**Bethesda-Chevy Chase Middle School #2, Preliminary Forest Conservation Plan, MR2014048**

Completed: 03/16/15

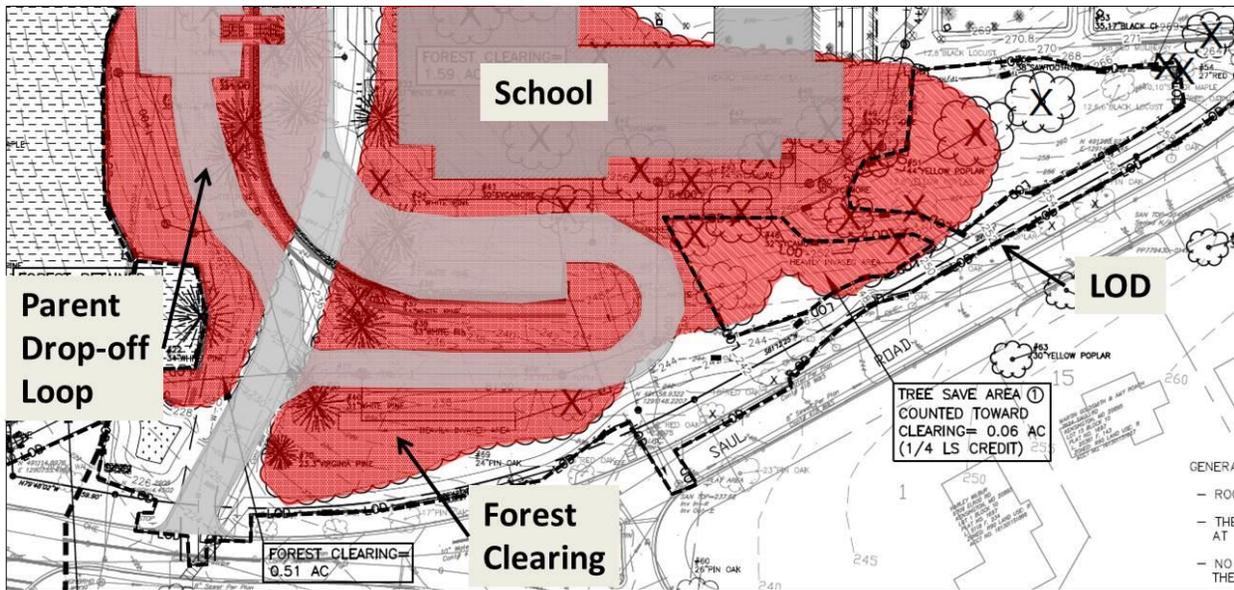
While some of the forest will be cleared to construct the school, approximately 1.2 acres will be cleared to build the parent-drop off loop. The parent drop-off loop shown on the PFCP was designed to meet the community's goal of reusing the existing curb cuts for the new school. The current site entrance on Saul Road is at an elevation of 222', while the school entrance is at an elevation of 258'. Meeting these two elevations with a

parent drop-off loop requires the use of a switch-back system with high retaining walls. While the current design meets some of the Applicant's goals, Forest Conservation Law requires that the Applicant maximize the retention of high priority forest.

There are other design options that would allow access to the site with the same architectural plan while retaining more high priority forest. Some of these options were shown in the Applicant’s feasibility study. For example, the Applicant could have created an entrance further up Saul Road, at a higher elevation, reducing the amount of grading and accompanying forest loss necessary for construction. The parent drop-off loop and pedestrian circulation systems could also be aligned, potentially saving more trees.

The Applicant is working with staff to design a new entrance and parent drop-off loop that will minimize grading and retaining walls and maximize forest and specimen tree retention. (Attachment 2)

# Variance Tree Locations

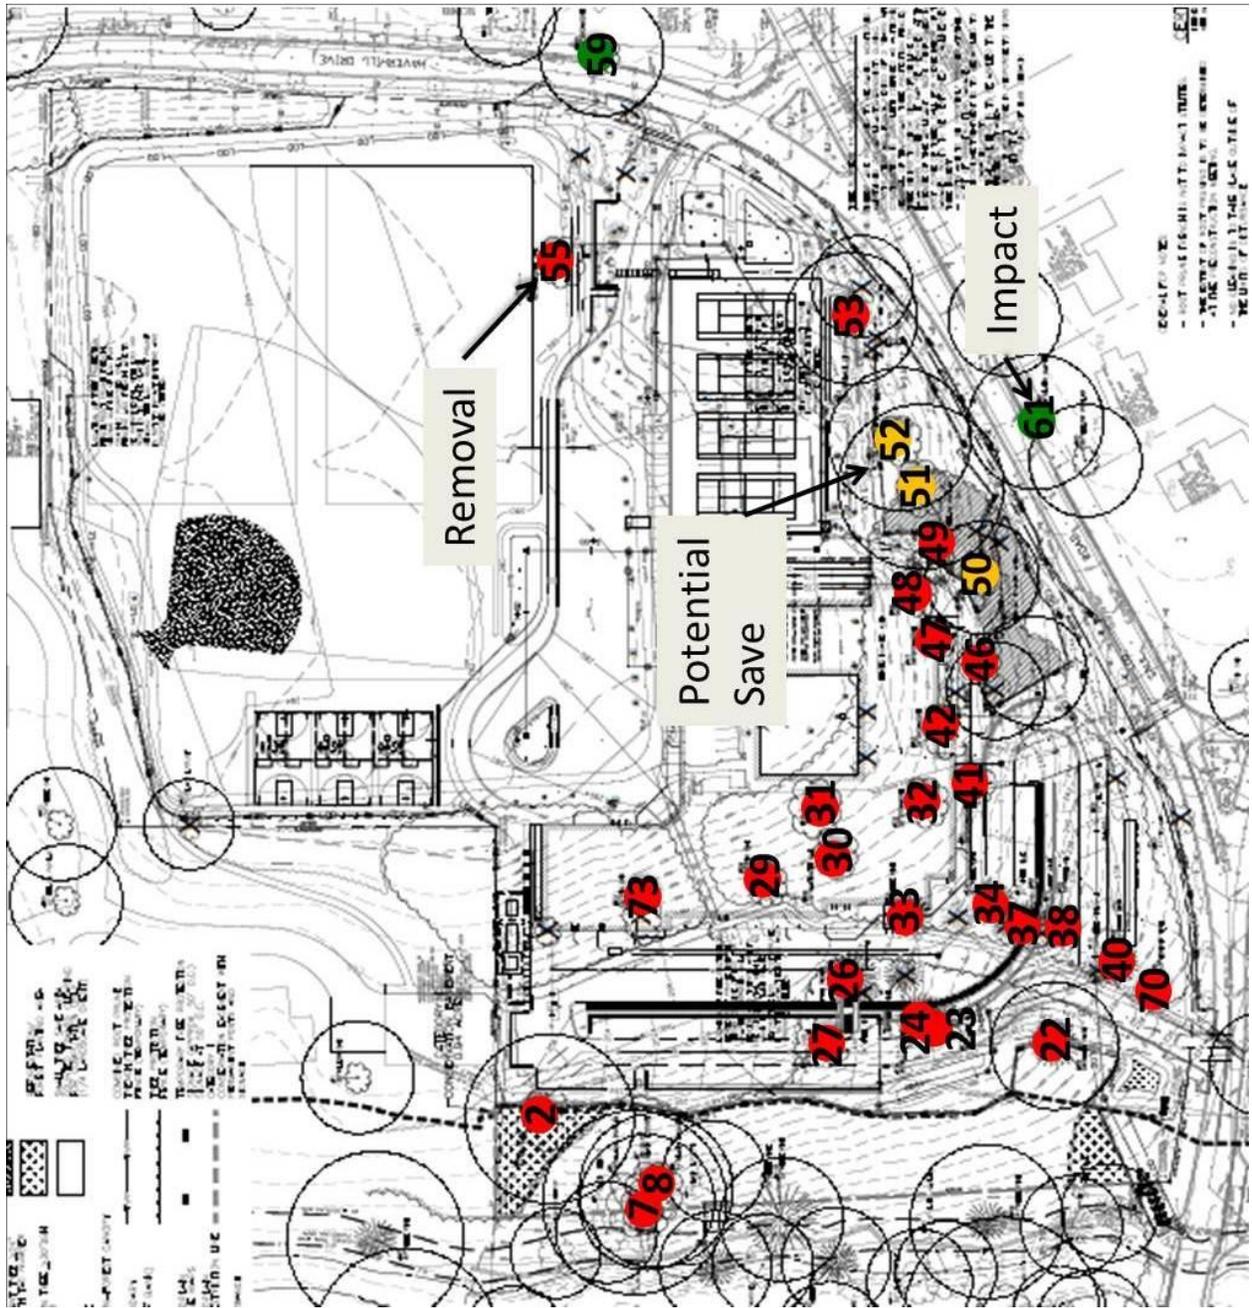
A redesign of the parent drop-off loop may be able to save the following trees: #22 34" white pine, #40 31" white pine, #70 23.3" Virginia pine (potential County champion).

The Applicant has also requested permission to remove two trees that are in fair/poor condition, but are outside of the proposed development area. Trees #7 36", 19", 15" multistem black locust and #8 41" black locust are located in the stream valley buffer with no proposed disturbance. Staff does not support the removal of these trees because they do not present a hazard because there are no potential targets if the trees suffer a catastrophic failure.

2. Remove trees #7 36", 19", 15" black locust and #8 41" black locust from the variance request.
3. Record a Category I Conservation Easement over all areas of forest retention and forest planting.

The Applicant must work with staff to realign the parent-drop off loop to minimized the impacts to trees #22 34" white pine, #40 31" white pine, #70 23.3" Virginia pine (potential County champion) and remove trees #7 36", 19", 15" multistem black locust and #8 41" black locust from the variance request. With the stated conditions, the requested variance will not confer on the Applicant any special privileges that would be denied to other applicants.
